CERTIFICATE OF APPROPRIATENESS

Property: 544 Harvard Street, lot 23, block 289, Houston Heights Subdivision. The property includes a historic 1,707 square foot, one-story wood frame single-family residence situated on a 6,600 square foot (50' x 132') interior lot.

Proposal: Alteration – Revision to COA granted by Planning Commission in October 2014.

The applicant now proposes to relocate the front porch steps from the north side to the west (front) and add brick wing walls.

WEST ELEVATION – FRONT FACING HARVARD STREET

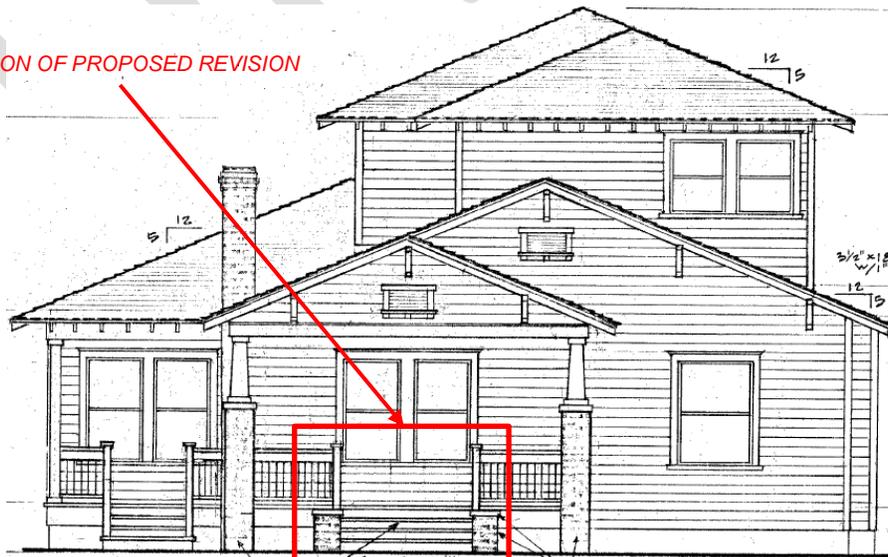
LOCATION OF PROPOSED REVISION

NORTH SIDE ELEVATION

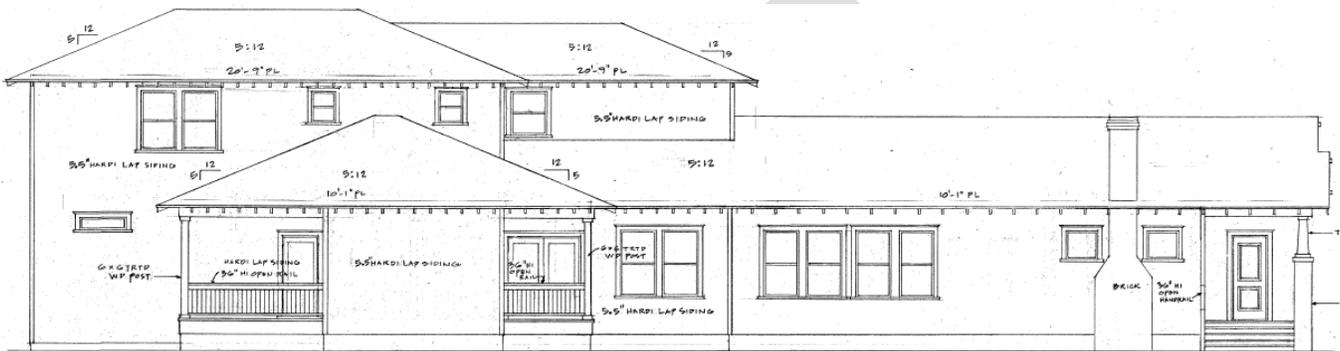
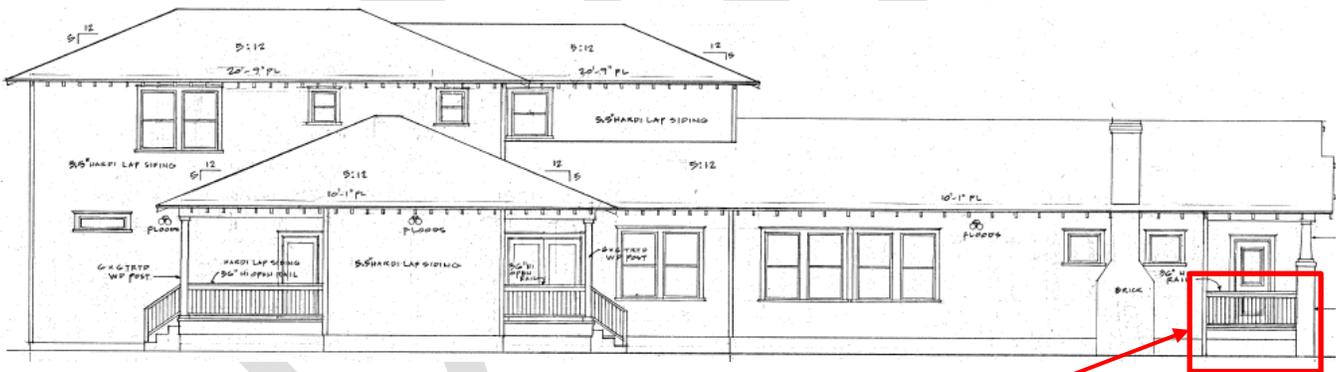
LOCATION OF PROPOSED REVISION

- Exterior Materials:** The approved COA includes a wood rail across the front porch and full width concrete steps on the north side of the porch. The steps are now proposed to be constructed on the front (west) flanked by a pair of brick wing walls with concrete caps. The north side of the porch will feature a wood railing.
- Front Elevation:** As approved, the front porch features a full-width wood railing. Concrete steps are now proposed to be centered on the porch with a pair of brick wing walls.
- Side Elevation:** As approved, the front porch features full-width concrete steps. No steps are now proposed for this side of the porch, and a full-width wood railing will be installed.
